Date: January 20, 2012

**SUBJECT: ADDENDUM NO.2 / STATE ROUTE 32 WIDENING (PHASE 1) –
PROJECT No. 15010 – FROM EAST OF PARK AND RIDE LOT TO EL MONTE AVE**

PROJECT NAME: STATE ROUTE 32 WIDENING PROJECT (PHASE 1)
PROJECT No. 15010

ADDENDUM NO. 2

HIGHWAY 32- PHASE 1
 LANDSCAPE IRRIGATION
 DETAILS

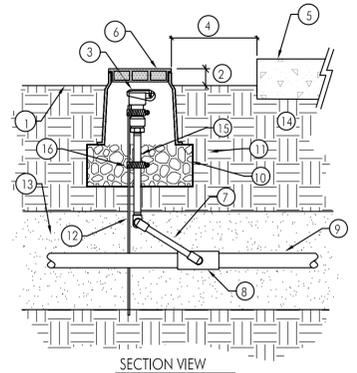
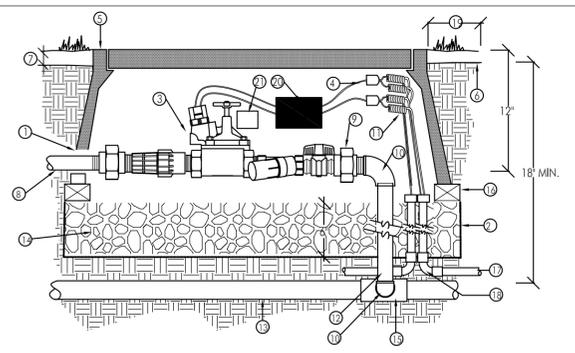
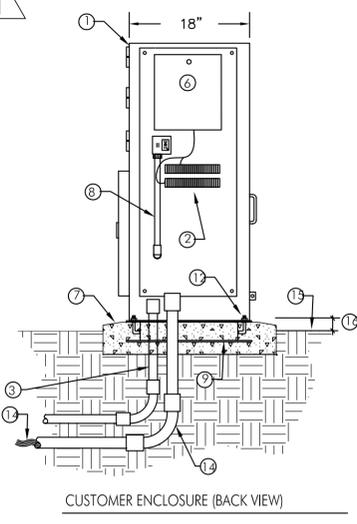
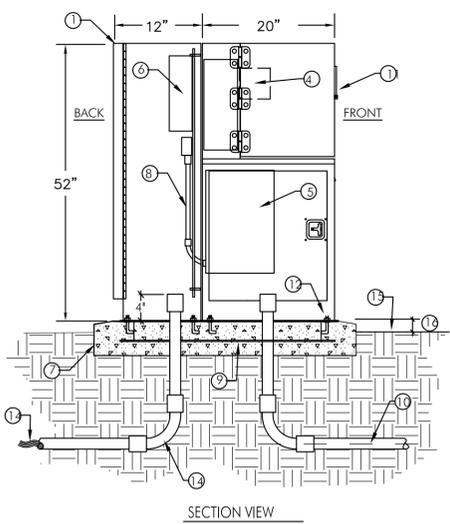
8	Plan Sheet LS-2.0	Irrigation Legend has been revised. Replace plan sheet LS-2.0 dated 1-11-12 with Revised LS-2.0 dated 11-19-12
9	Plan Sheet LS-2.8	Detail 2, Backflow Preventer Detail, has been revised. Replace plan sheet LS-2.8 dated 1-11-12 with Revised LS-2.8 dated 11-19-12
